# *Final Value Engineering Study Report*

## *Widening of Hillcrest Parkway*

*CSSTP-0007-00(413), PI No. 0007413, Laurens County, Georgia*

Subject: Final Study Report  
**Widening of Hillcrest Parkway**  
City of Dublin, Laurens County, Georgia  
CSSTP-0007-00(413), PI No. 0007413

**VE ALTERNATIVE 1.0**

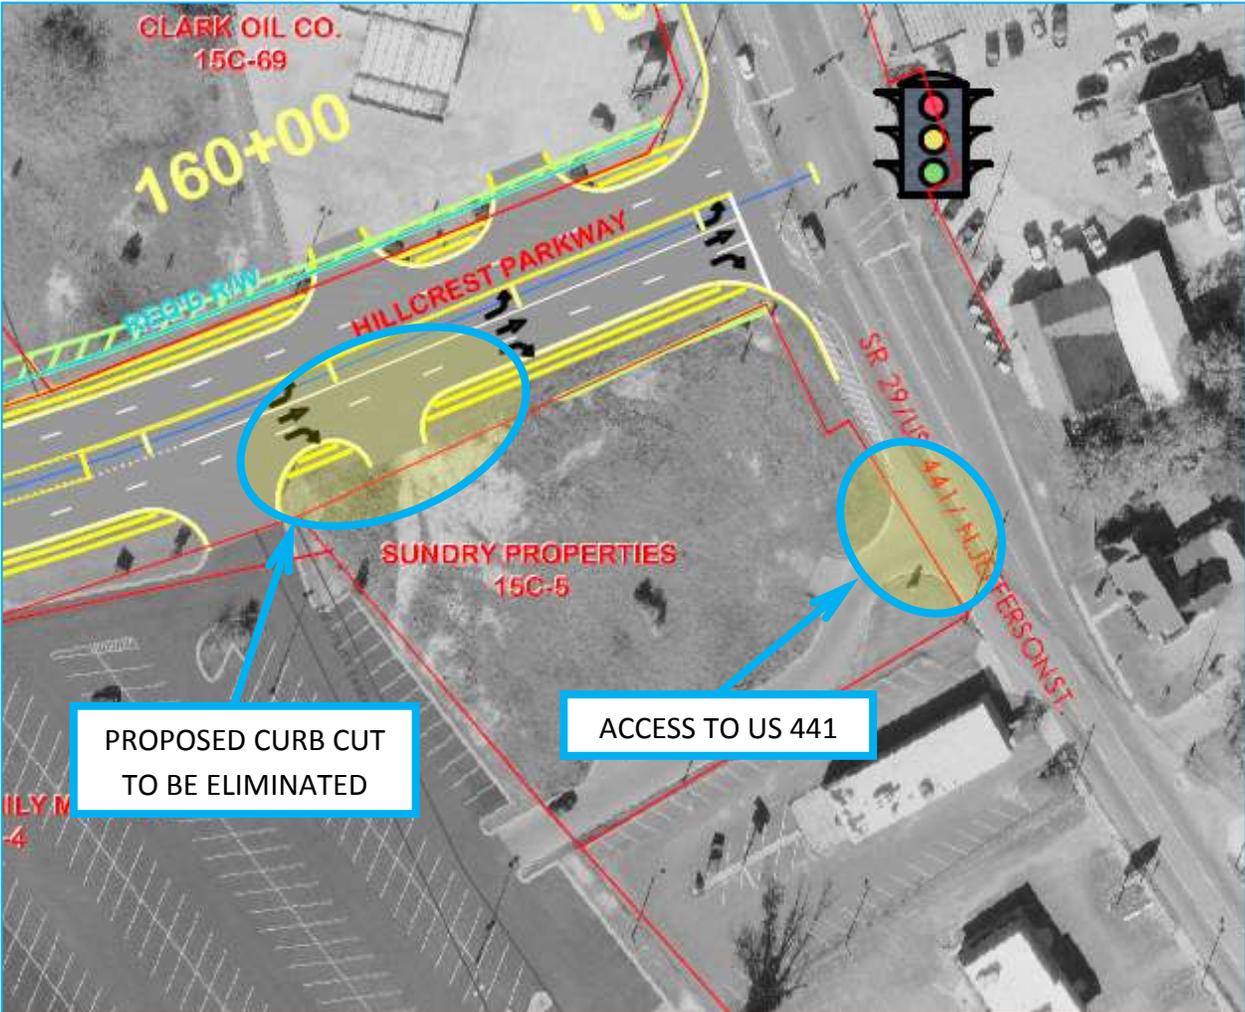
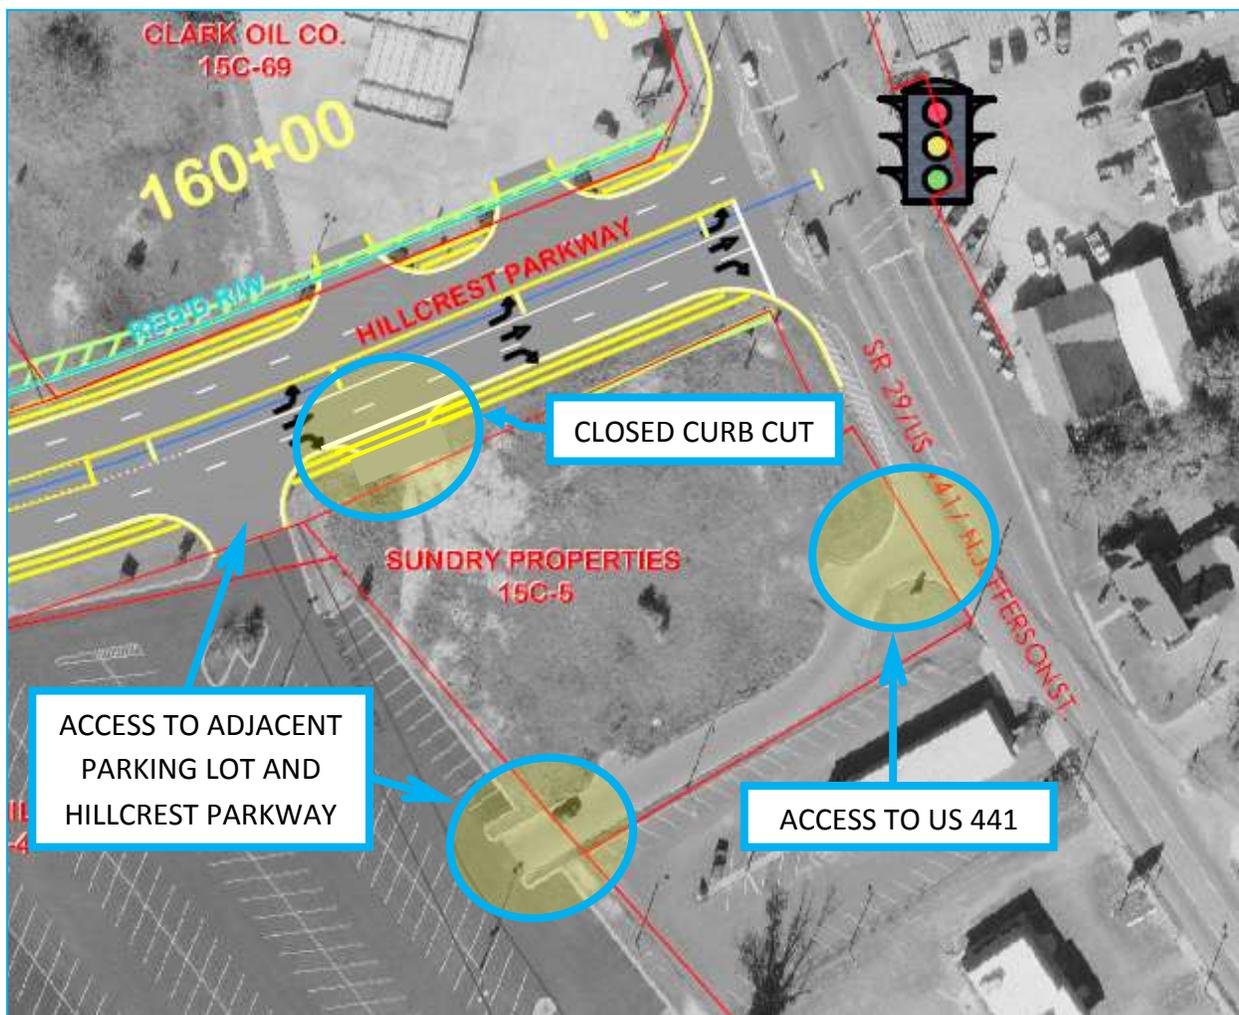
**Description of Baseline Concept:** The baseline concept indicates a new curb cut and driveway for the Sundry Properties, Inc. land parcel on Hillcrest Parkway approximately 200 feet from the Hillcrest Parkway/US 441 Intersection. This curb cut/driveway is at the beginning of the eastbound right-only queue lane on Hillcrest Parkway to US 441. Access to this property is maintained from southbound US 441.

**Description of Alternative Concept:** Eliminate the proposed curb cut and new driveway from Hillcrest Parkway onto the Sundry Properties, Inc. land parcel.

**Discussion:** Operationally, a driveway in close proximity to a major intersection such as the one at Hillcrest Parkway/US 411 is not prudent. Since the 2035 morning peak hour traffic count is 455 vehicles per hour, the right-only queue lane (eastbound Hillcrest Parkway to southbound US 441) will be heavily used. As such, the proposed driveway could create a bottleneck, congestion, and delays.

Accessibility to this property is still available from US 441 and from the adjacent parking lot directly to the west of the Sundry Properties, Inc. parcel. It appears the latter access point has been in use for some time and is a well defined access point.

**VE ALTERNATIVE 2.0**

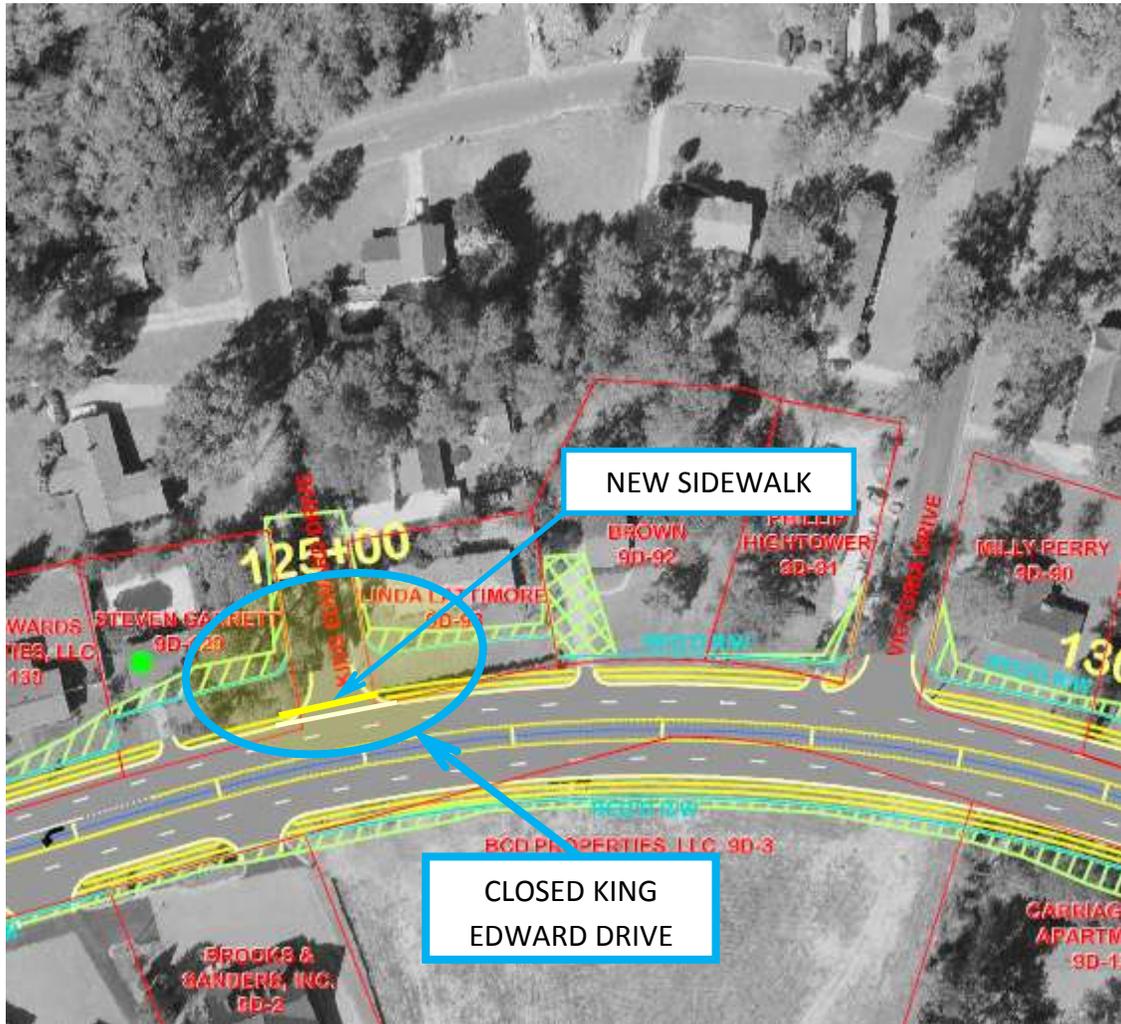
**Description of Baseline Concept:** The baseline concept indicates an improvement to the existing King Edward Drive access on Hillcrest Parkway. This street is approximately 350 feet west from Victoria Drive. Additionally, King Edward Drive is approximately 400 feet east of the Hillcrest Parkway/Claxton Dairy Road Intersection. The property immediately to the east of King Edward Drive on Hillcrest Parkway is being taken due to the vertical profile of the terrain and road widening.

**Description of Alternative Concept:** Eliminate the existing connection between King Edward Drive and Hillcrest Parkway.

**Discussion:** Operationally, a driveway in close proximity to a major intersection such as the one at Hillcrest Parkway/Claxton Dairy Road is not prudent. This is especially true considering that Victoria Drive is 350 feet to the east of King Edward Drive. The 2035 peak hour traffic count considers both of these streets to be “minor movements” with minimal traffic. In fact, the only viable count, 25 vehicles per hour, is southbound Victoria Drive to westbound Hillcrest Parkway. As such, any additional residential traffic from King Edward Drive onto Victoria Drive is minimal and easily achievable. This closure eliminates potential bottlenecks, merging traffic, and delays.

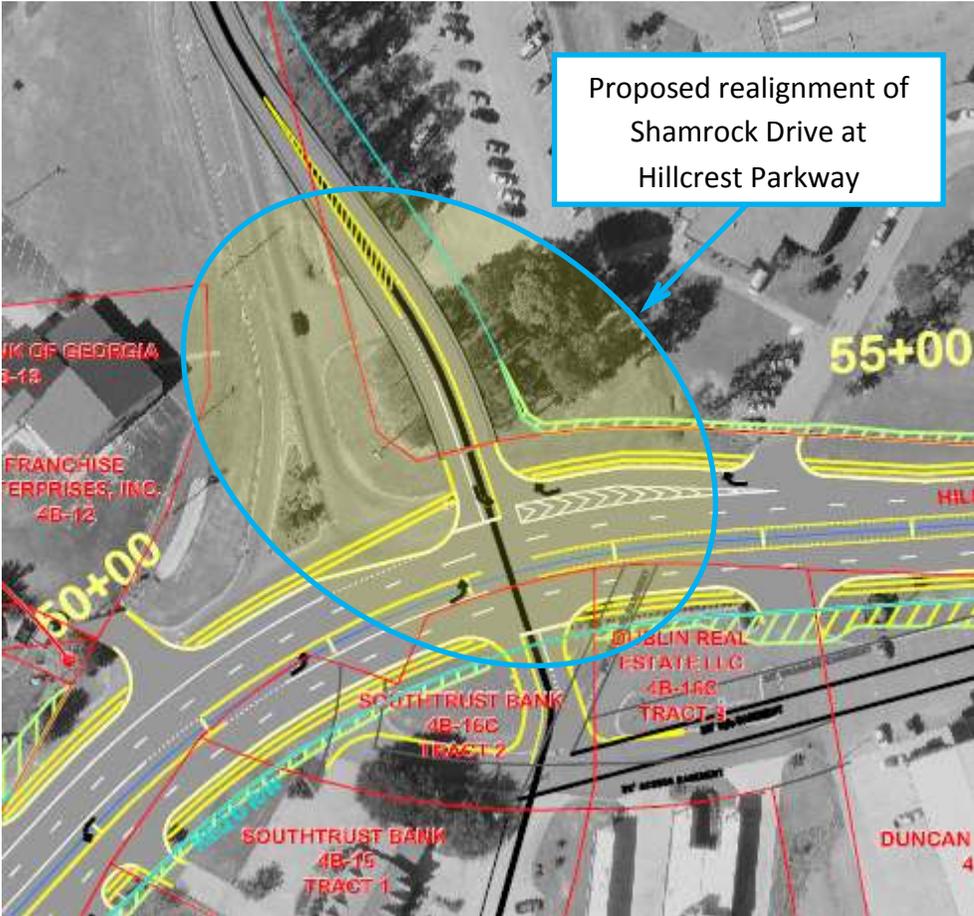
**Discussion:** Left turns exiting Shamrock Drive are 23% of the total exiting traffic onto Hillcrest Parkway. This left turn lane is 500 feet east of the Hillcrest Parkway/US 80 Intersection and 150 feet west of the entrance to the Dublin City High School. Eliminating the left turn movement from southbound Shamrock Drive to eastbound Hillcrest Parkway and eastbound Hillcrest Parkway to northbound Shamrock Drive would reduce the likelihood of accidents at this intersection.

It is noted that access to eastbound Hillcrest Parkway from southbound Shamrock Drive would require longer drives; e.g., (1) departing the City of Dublin High School northbound on Shamrock Drive to eastbound Brookwood Drive to southbound Brookhaven Drive to Hillcrest Parkway – a distance of about 1.75 miles; or (2) departing the City of Dublin High School northbound on Shamrock Drive to eastbound Mall Road to southbound US 80 to Hillcrest Parkway - a distance of about 0.85 mile. See aerial on the following page.

**VE ALTERNATIVE 3.0**

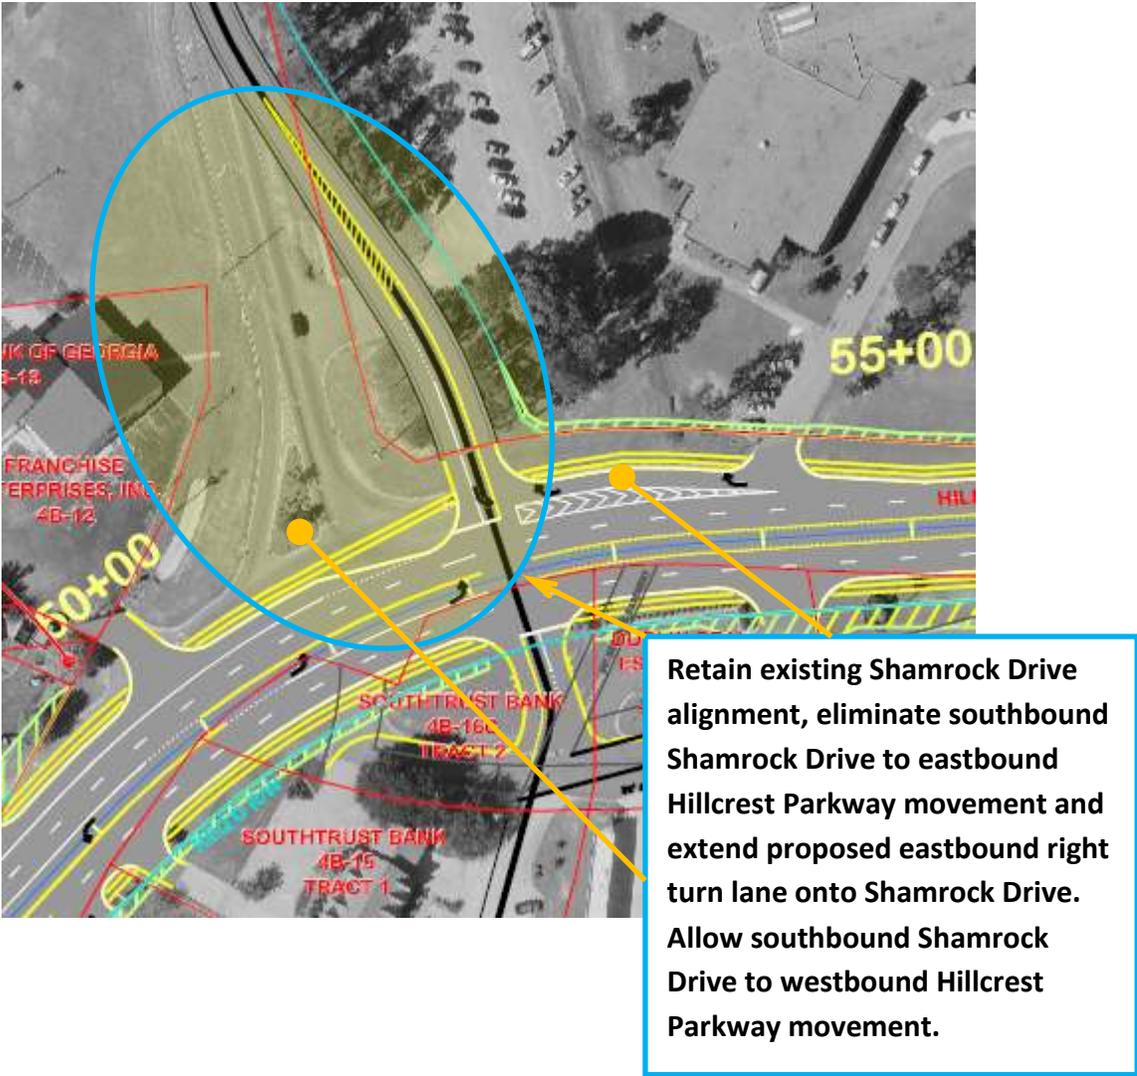
**Description of Baseline Concept:** The baseline concept shows a realignment/relocation of Shamrock Drive to the east to accommodate left and right turns onto Hillcrest Parkway, as well as a through movement to access businesses on the south side of Hillcrest Parkway.

**Description of Alternative Concept:** Maintain the existing alignment along Shamrock Drive and provide only right-in/right-out movements and eliminate the through movement that crosses Hillcrest Parkway.

# VE ALTERNATIVE 4.0

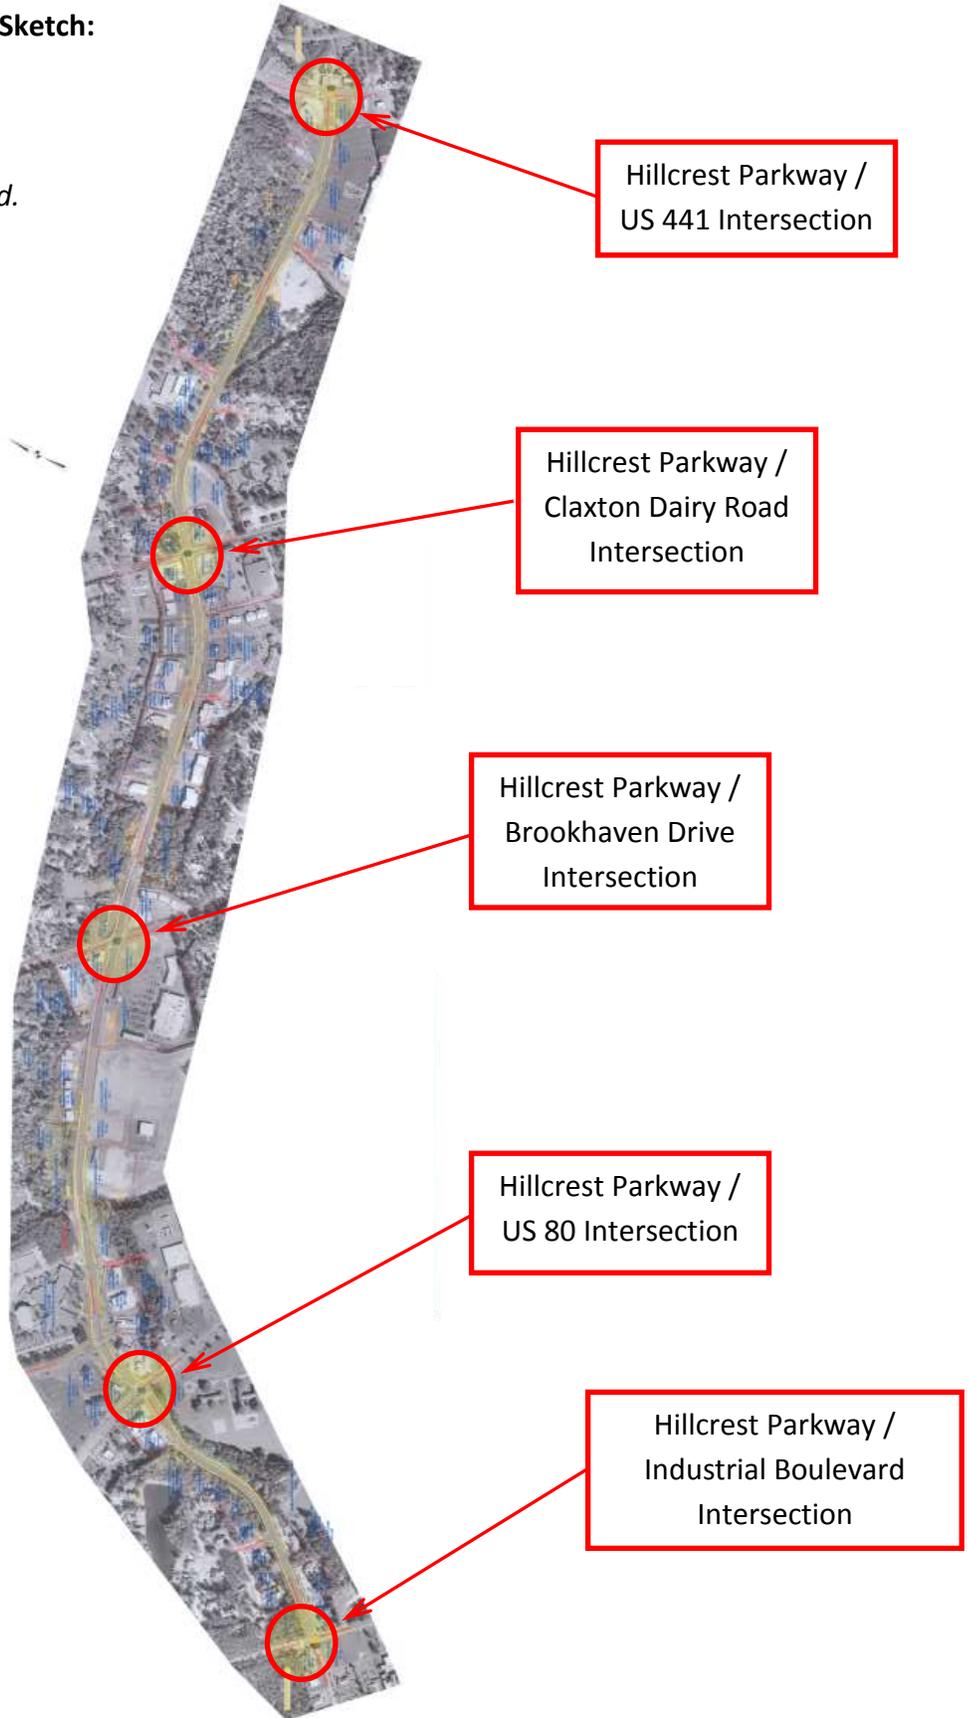
**Description of Baseline Concept:** The baseline concept as shown does not provide for interconnectivity between all signals along the corridor.

**Description of Alternative Concept:** This alternative suggests providing interconnection between all the signals along Hillcrest Parkway and synchronizes the signals' timing.

**Discussion:** The start/stop traffic flow surges can be ameliorated by interconnecting all the signals along the corridor, providing faster movement thus reducing travel time. As a result, the implementation of this alternative could also allow the facility to handle more traffic. The additional required cost is acknowledged but the added value/offset of time savings may be worth the added costs. The placement of the conduit will be easily accommodated.

*Signalized intersections to be interconnected and synchronized.*
